Product Change Notification

110804 - 01

Change Notification #:	**110804 - 01**
Change Title:	**Intel(R) Server System R1304BTLSHBN, Single, PCN 110804-01, Product Design, Product Material, Update Hot Swap Backplane, Reason for Revision: Update the TA number and the Projected Date**
Date of Publication:	**August 02, 2011**

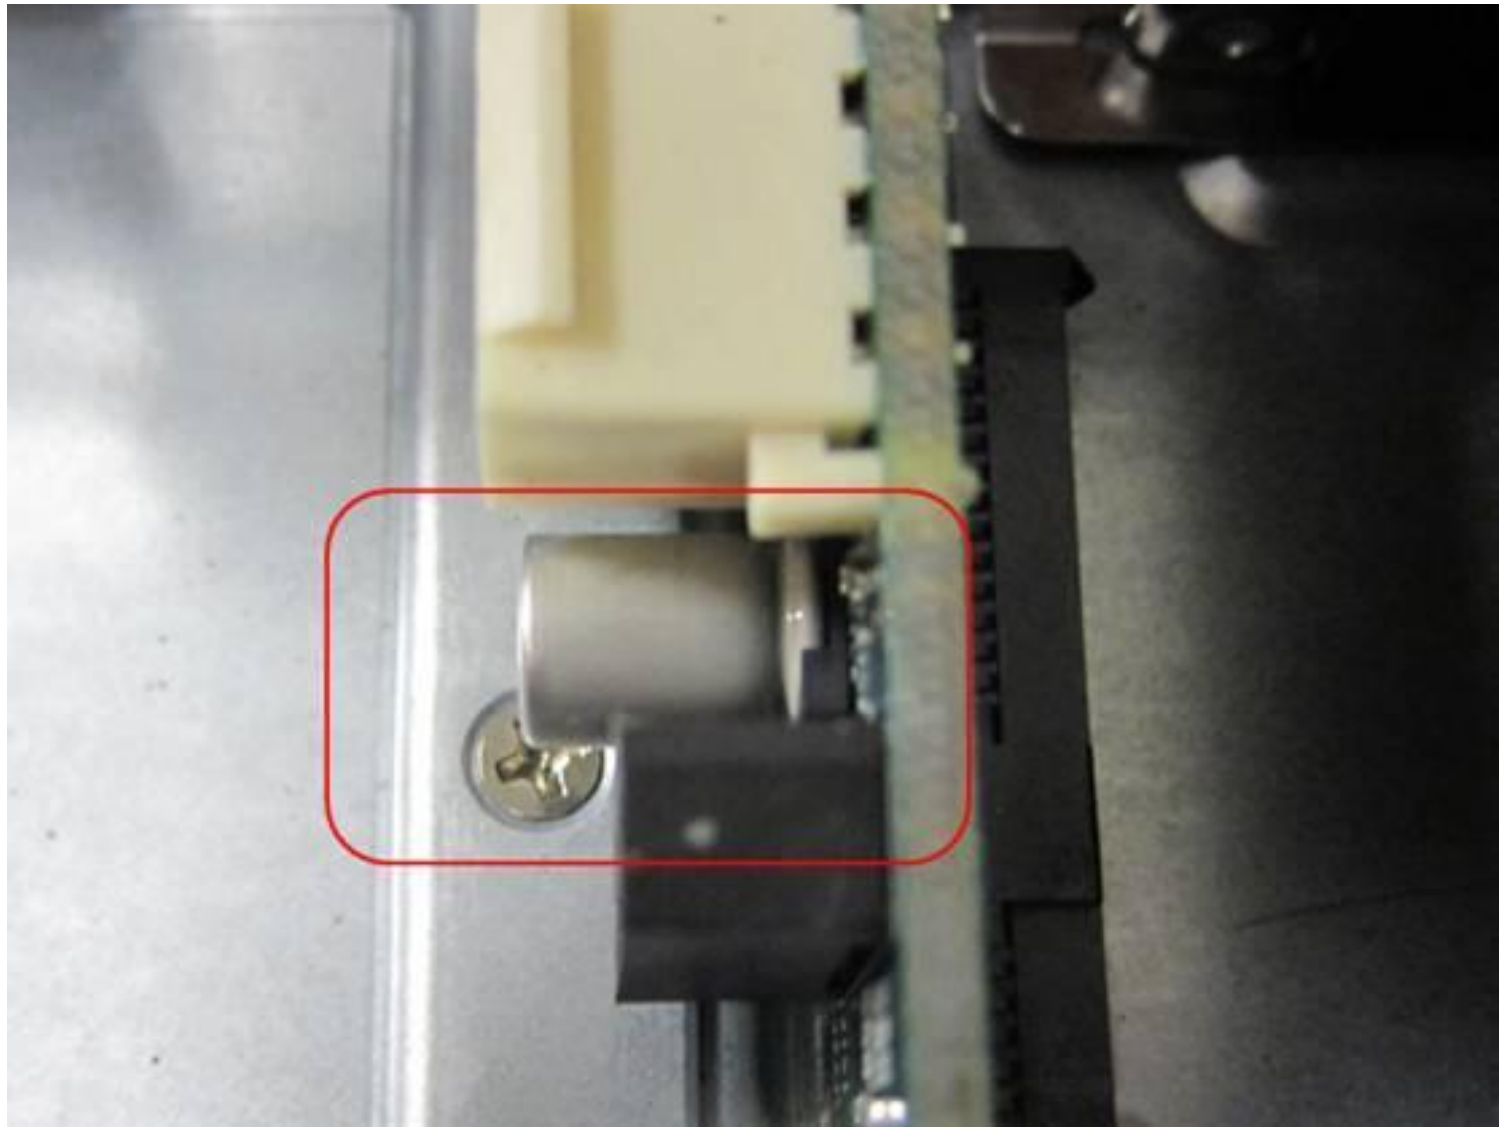
Intel is updating the Hot Swap Backplane (HSBP) from Printed Board Assembly (PBA): G10396-204 to G10396-205 by changing the size of the capacitor to improve the HSBP assembly on the Intel® Server System R1304BTLSHBN. The height of the capacitor changed from 12.0mm to 7.7mm. The following is the picture of the old capacitor.
